Lead Local Flood Authority

RE: AWDM/0628/26 - Land Between Sword Street And Martlets Way Worthing West Sussex (Durrington Gasworks Phase 2)

This is a Full planning application for a mixed-use development comprising 123 dwellings and commercial floorspace together with associated parking, landscaping, open space and drainage [Land at Durrington Gasworks].

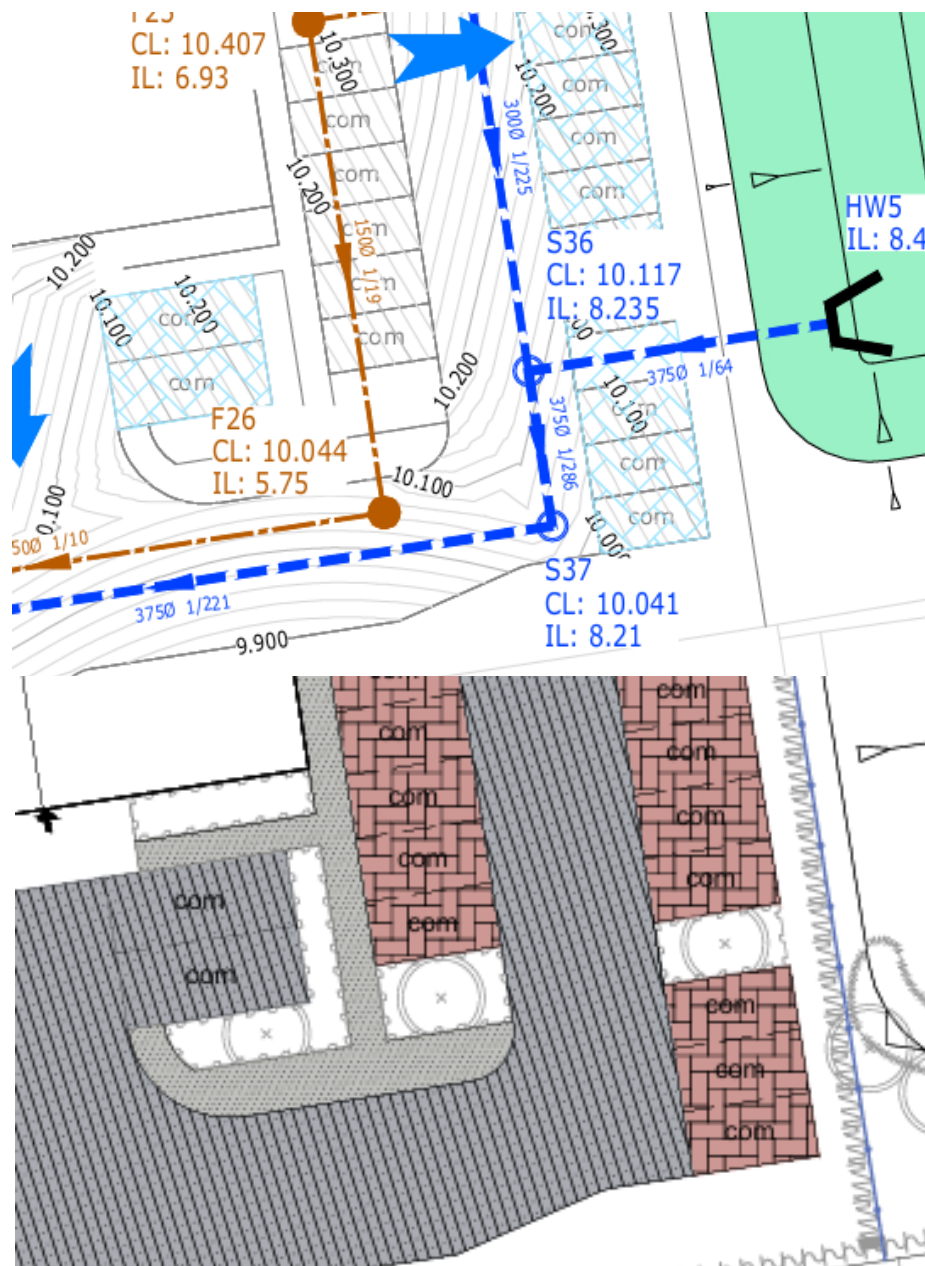
While the FRA and Drainage Strategy states that there is full containment of surface water runoff for storm events up to and including the 100-year plus 45% allowance climate change”, the hydraulic model calculations demonstrate that there is some surface water flooding occurring in the 1 in 100 year plus climate change event. A more detailed exceedance plan for the 1% AEP event plus climate change is required. While Figure 6-1 is provided, the plan should include any areas/depths of flooding from the drainage network.
